Historic Preservation Design Review

March 24, 2011

HP-11-09, corner N. Washington & Hampton St. (City)

Request: Historic Preservation Design Review for proposed changes to the exterior of the building and site plan

The specifications and design of the brick screenwall are shown below.

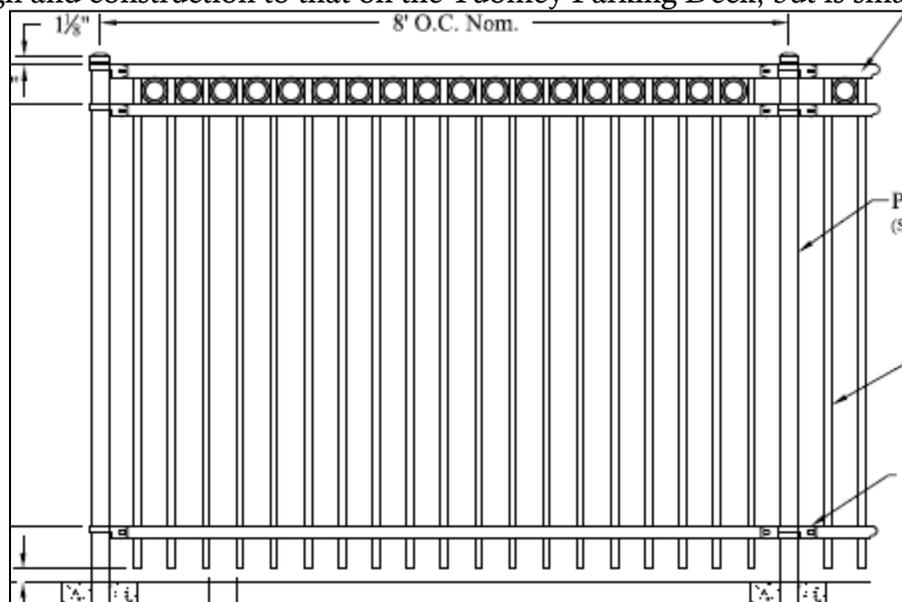
- The installation of a 7' 9" brick screenwall on the Washington Street façade at the southwest corner of the building to protect oxygen storage tanks. The specifications for the wall are "Velve-Tex Red" Face brick from Boral, Inc., installed to match the building in pattern and type. Velve-Tex is a soft-finish velvet surface pattern with natural modulations in color described by one distributor as:

The architectural specifications further direct the Mason to “cull 5% of dark brick to match MOBII masonry.” This will ensure the best possible match to the existing wall of the building, shown in the photo to the right.

The proposed brick screenwall, black metal fence, and gates are in accordance with these requirements, and clearly conform to the intent of the guidelines to assure harmony with the existing architecture and streetscape along Washington Street and Hampton Avenue.

Fencing location and installation details are shown below.

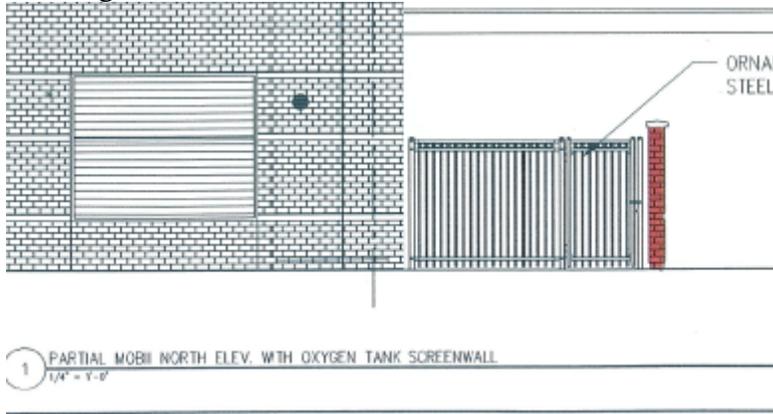
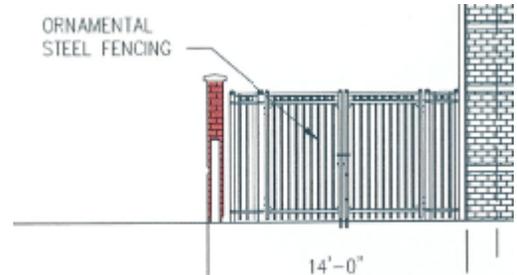
- Ornamental steel fencing and gates on either end of the brick enclosure as specified on the architectural drawings (Sheet AS2.1, AS2.2). The specifications are stated as Ameristar-Aegis II Majestic 3 Rail steel ornamental fence system with Rings, 7' height in Black. This fencing is similar in design and construction to that on the Tuomey Parking Deck, but is smaller in scale.

In addressing the relocated landscaping elements, the architect has proposed a layout depicted in the sketch below.

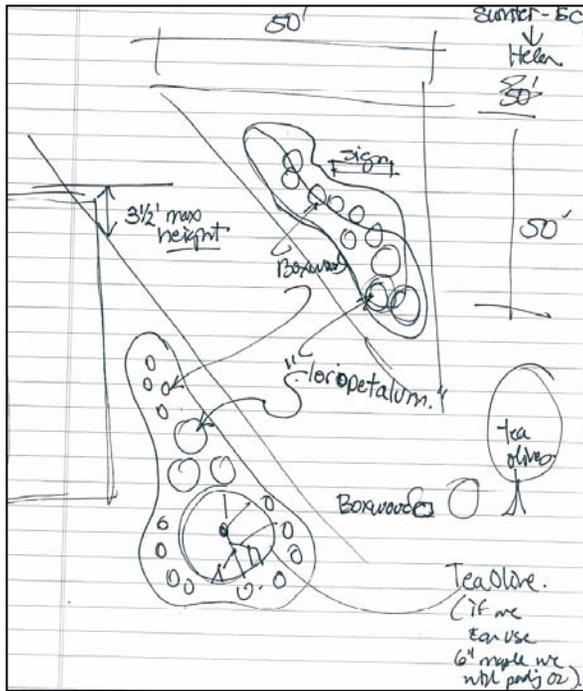
The landscaping sketch depicts relocation to two areas in front of and away from the new screenwall and on either side of the new driveway, containing shrubbery and trees in undulating pattern that is similar to and compatible with the existing landscaping and screening along the Washington Street frontage. Site constraints may dictate some adjustment from this sketch. Also, species identified as "tea olives" are actually Little Gem magnolias.

The proposed changes to the landscaping are in accordance with these guidelines.

4. That Staff have the authority to approve the final landscaping plan, in accordance with what has been presented in the sketch provided by the architect. Should any existing affected tree or other shrub or plant be unfeasible to work back into the site, it shall be relocated in an area within the Tuomey campus, in as close proximity as is feasible to the project area, or alternatively donated to the City or a non-profit entity for relocation in the immediate area of Washington Street and the Tuomey Hospital property.
